### PRELIMINARY FINDINGS AND DETERMINATIONS

#### Type II Zoning Permit Mountain Lion Retail Special Review #929

**TITLE:** Mountain Lion Retail –Special Review #929  
(PZ #16-0200)

OVERALL SITE PLAN

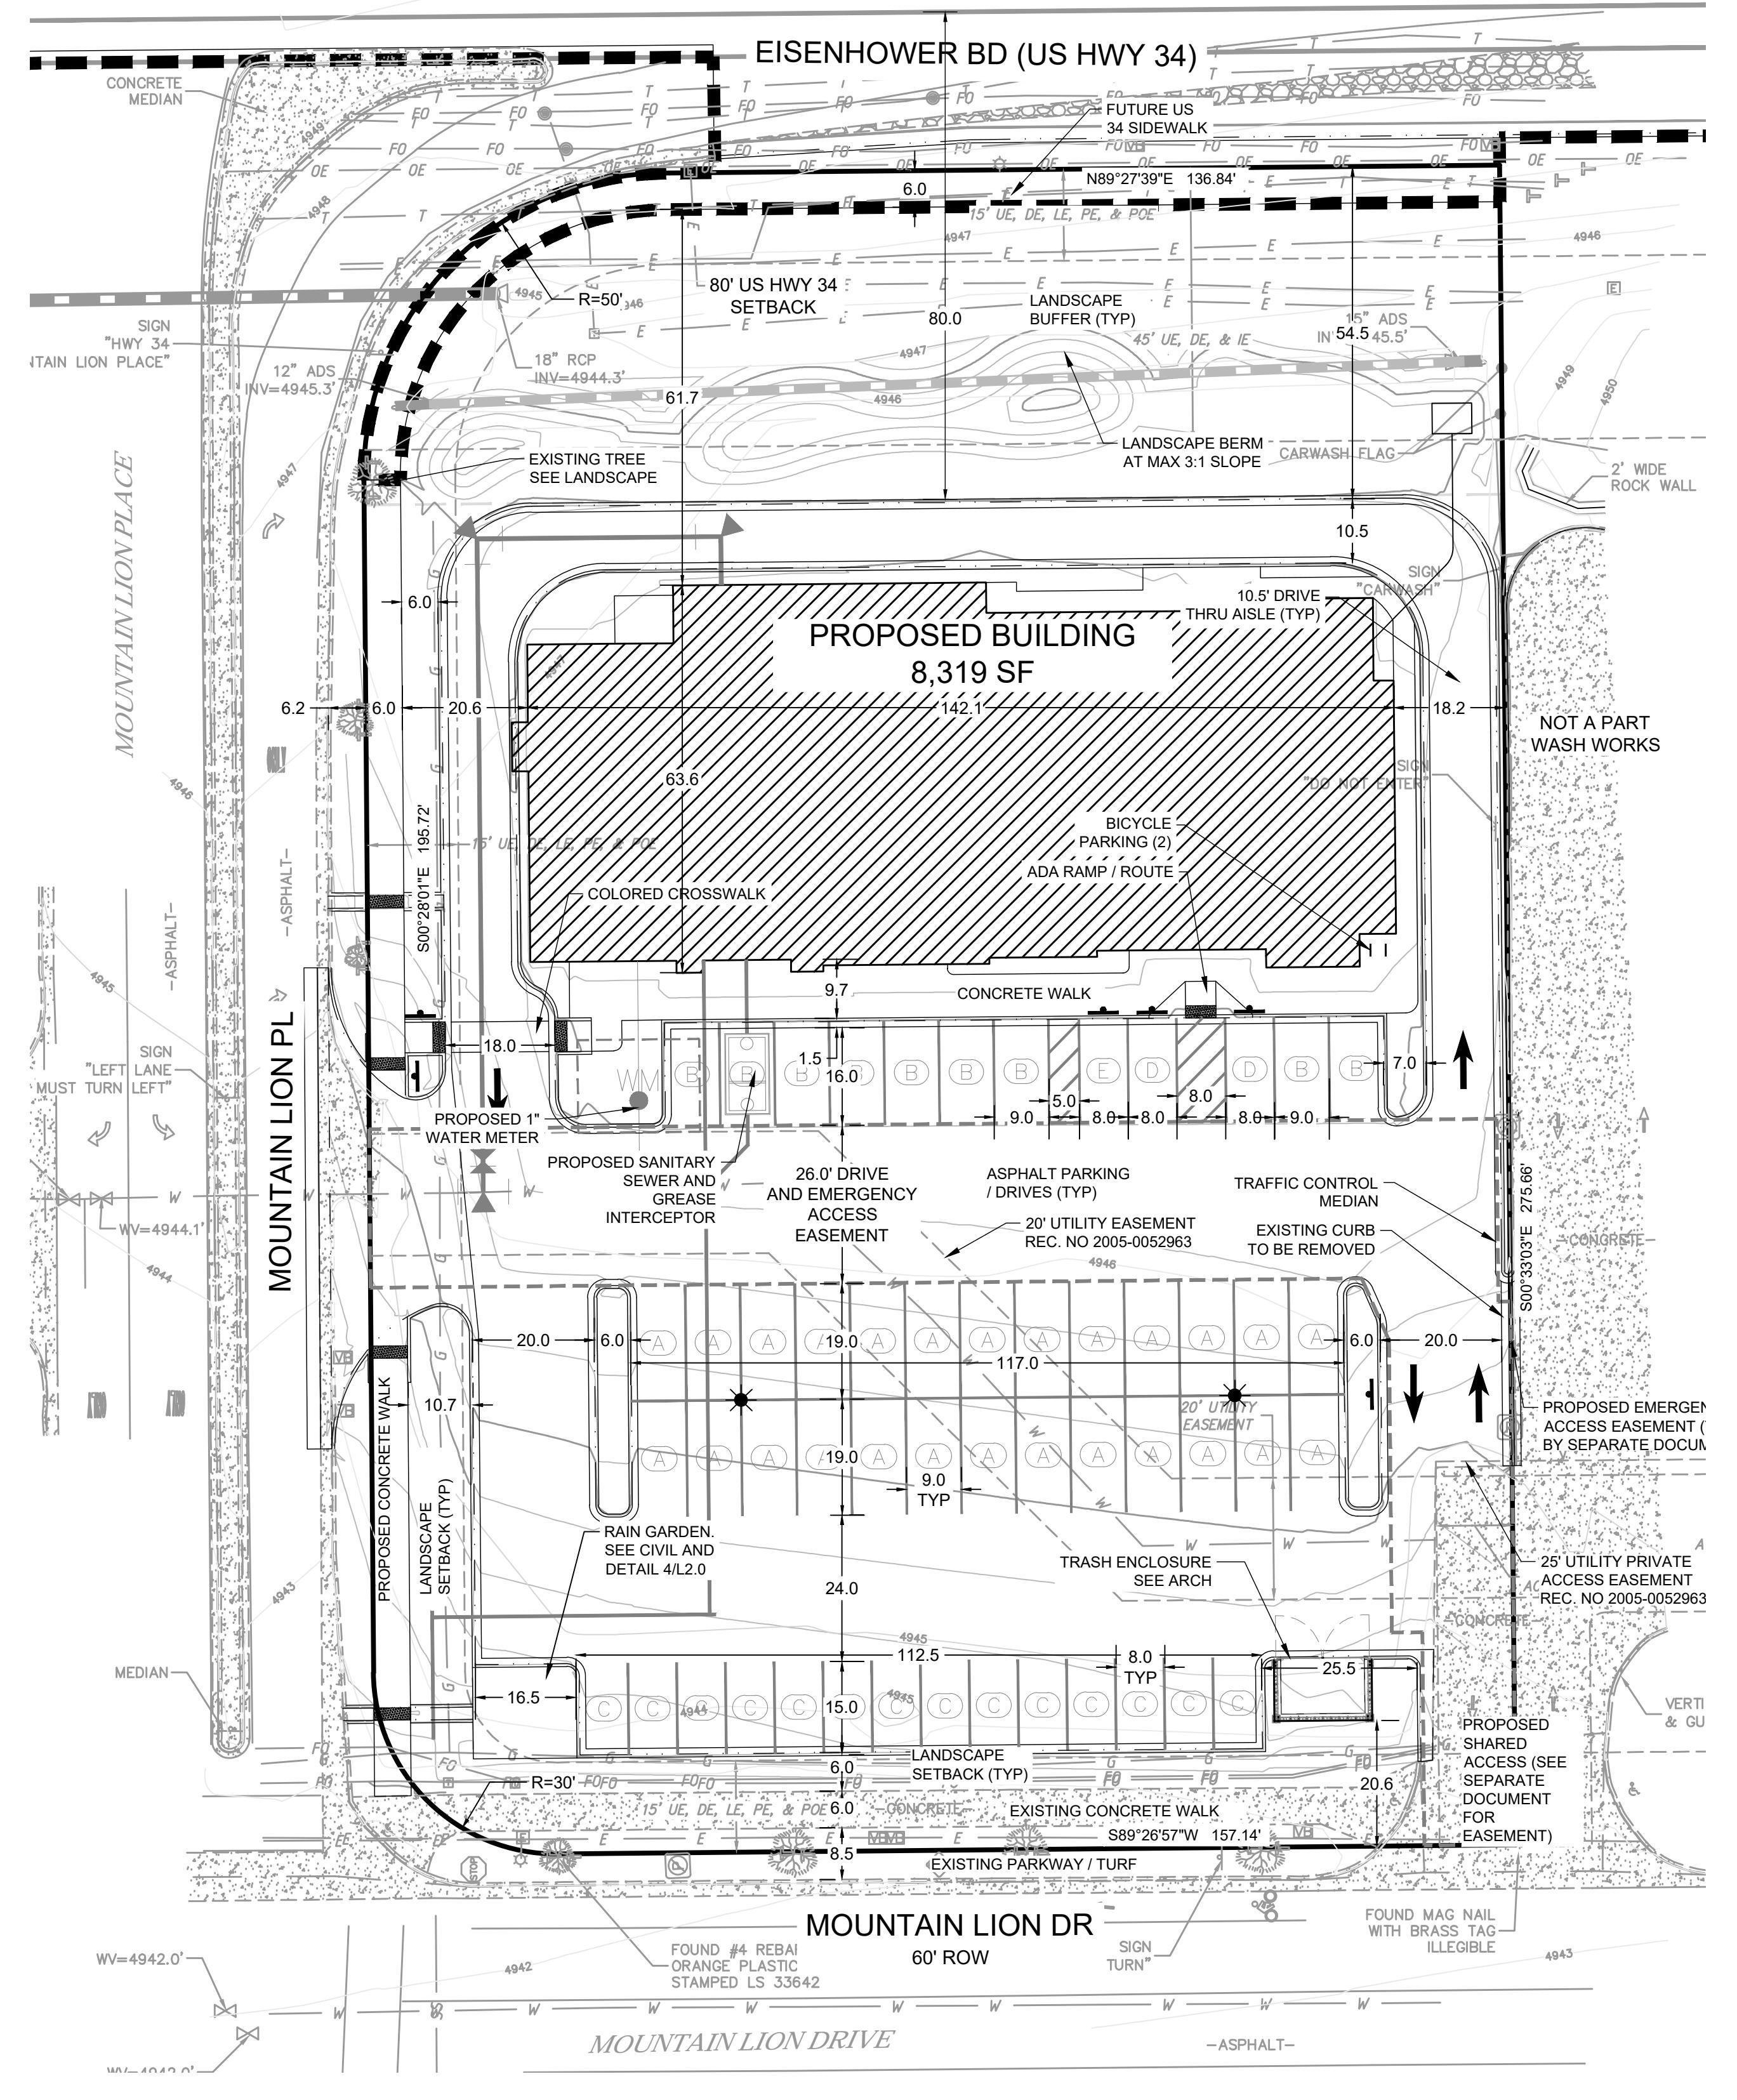
Configuration and placement of vehicular and pedestrian access and circulation is compliant with City standards. A 6' wide detached sidewalk along Mountain Lion Place and Mountain Lion Drive gives pedestrians ample access and connection to the surrounding properties. Primary vehicular entry and exit points are at two locations 1) on Mountain Lion Place with emergency access and 2) on Mountain Lion Drive, sharing access with the adjacent car wash site. Both Transportation and Fire Department staff have reviewed the special review plans and have indicated compliance with the City's Adequate Communities Facilities Ordinance.

Per the City of Loveland's parking requirements, 1 space is needed for every 300 SF of office space with an additional two spaces for employees, totaling 9 spaces and 1 handicap which are provided. A place for 3 bicycle parking spaces is also accommodated per the code and is in compliance. Additionally, parking is oriented inwards and does not adversely affect those along Eisenhower Boulevard.

**ARCHITECTURAL ELEVATIONS**

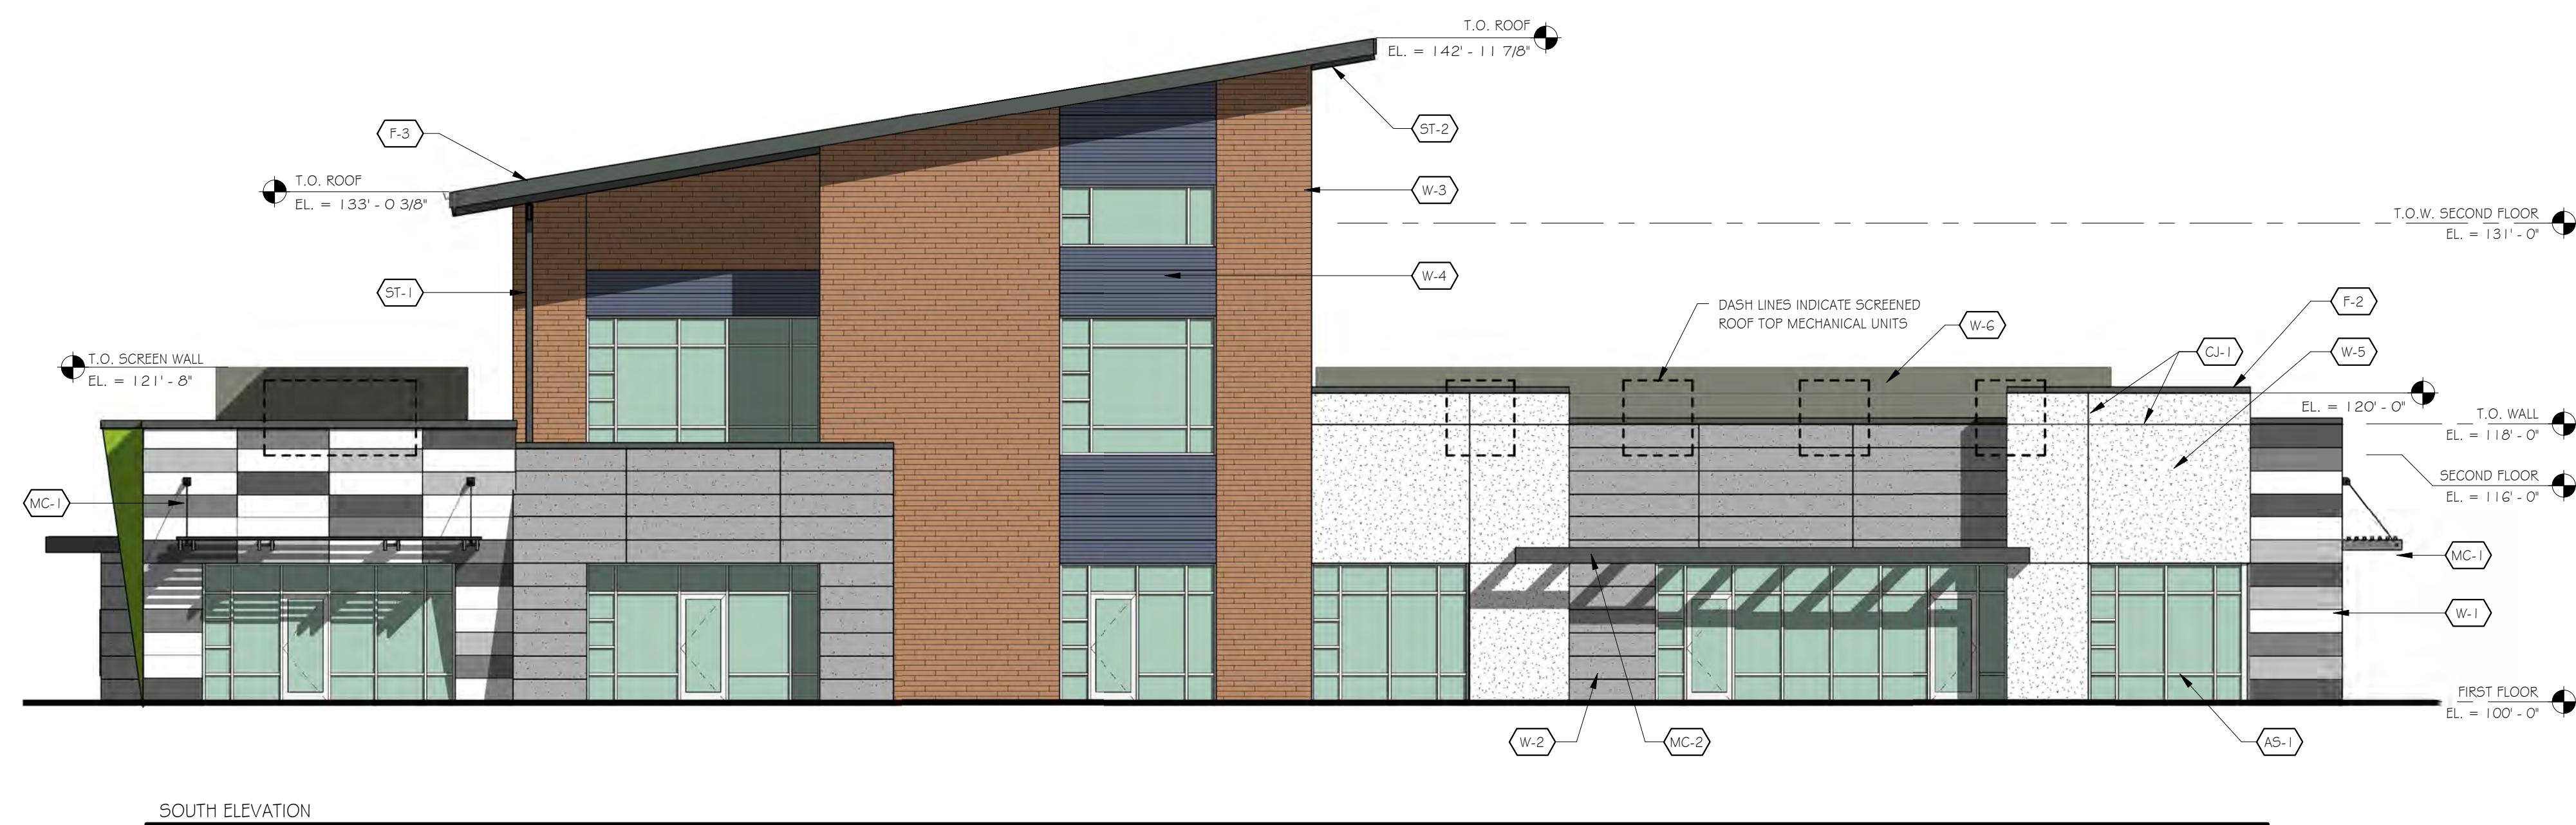
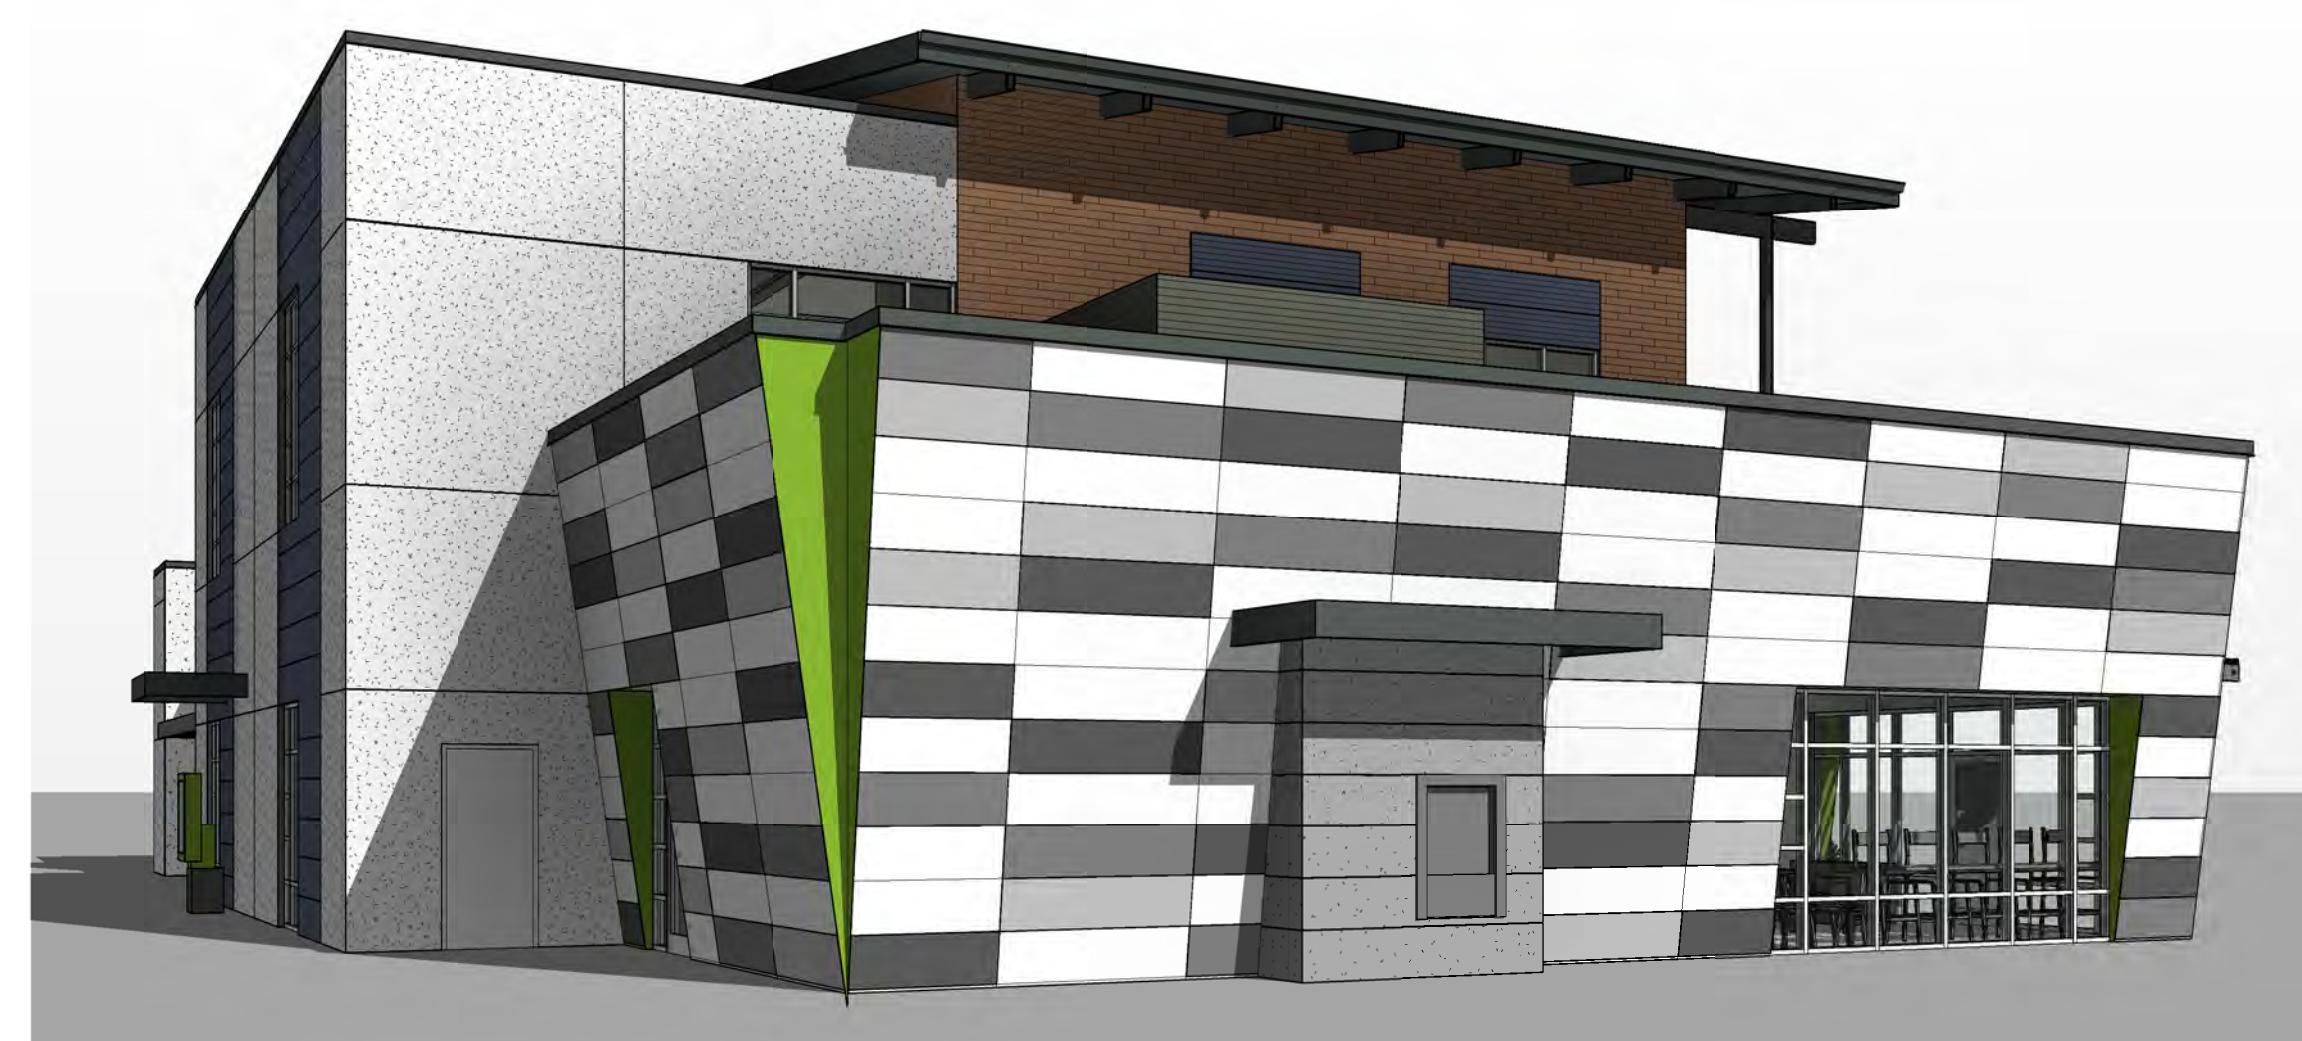
Development of the in-line retail is in a similar, but more modern design motif as the surrounding commercial corridor. In kind storefront style windows cap the prominent two-story building as to assimilate itself with other neighboring commercial buildings while the overall material composition remains consistent by using concrete & stucco veneers, and brick look-alike paneling systems.
